Annex: HVDC Code comments

Dr. Geraint Chaffey, Dr. Willem Leterme, Firew Dejene, Mian Wang, Alejandro Bayo Salas, Thomas Roose, Ozgur Can Sakinci, prof. Jef Beerten, prof. Dirk Van Hertem

Department of electrical engineering (ESAT), Research Group Electa, KU Leuven
Electrical networks group, EnergyVille

Introduction

2.1.6:

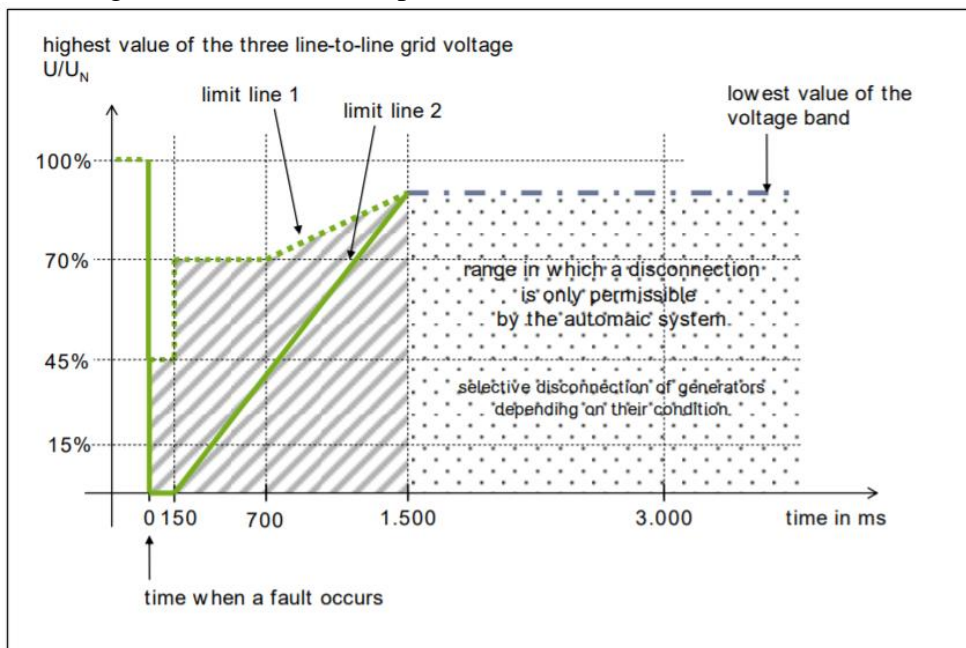
- To allow for different options towards multi-terminal extension, the parameter “specify limit for maximum loss of active power” could be extended with an interval during which this active power is lost. The interval specification during which the active power is lost, is considered in standardization working groups (CENELEC) and is an ongoing topic within research (Promotion, Abedrabbo et al.).
